IEEE 802.16-05/042r5

Document under Review: **P802.16-2004/Cor1/D3**

Ballot Number: **0001008**

Replace Figure 84 with the following figure:

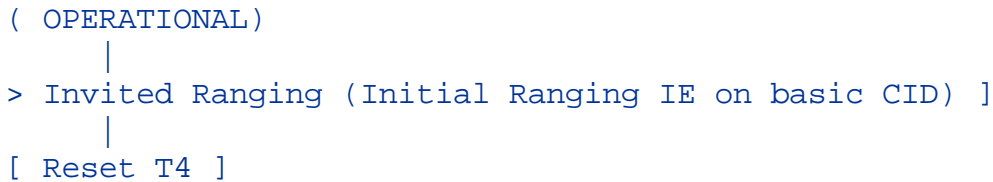
The standard has the notion of invited ranging opportunities however it is not clear that in periodic ranging the BS has the right to use invited ranging opportunities (initial ranging IE addressed to the SS basic CID). It's implicitly allowed in the BS FSMs (figure 82 & 83) but it's not mentioned on the SS side (figure 84).

Figure 84 should mention this case.

[In 802.16-2004/Cor1/D3, page 52, line 55, insert the following text:]

[Copy figure 84 from the standard and add one box between operational and reset T4 on the left side of the diagram]
